Access Compliance Report Public Rights-of-Way (Curb Ramps)

Main Street: MESA_DR Cross Street: SANTA_ANA_AVE Location: S

ADA ID: RPAT220128170159 Ramp Type: Type 1 - Perpendicular Diagonal Initial Pass/Fail: Fail Overall Compliance: No Severity Score: 0

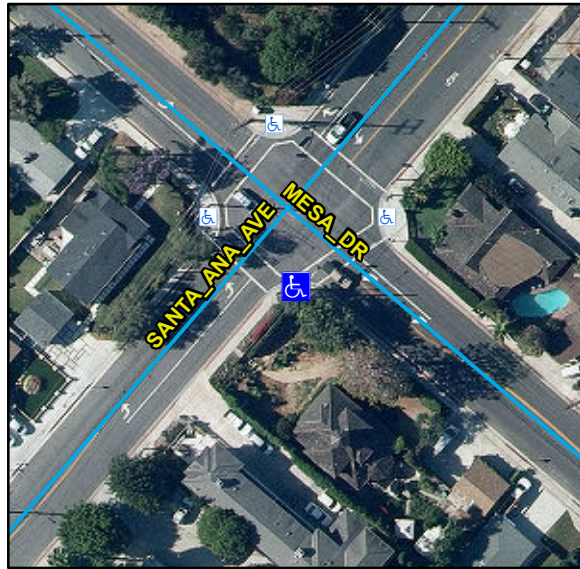
R304.2.2, STD 1115

Remove & Replace Curb Ramp With Two New Directional Ramps or Equivalent.
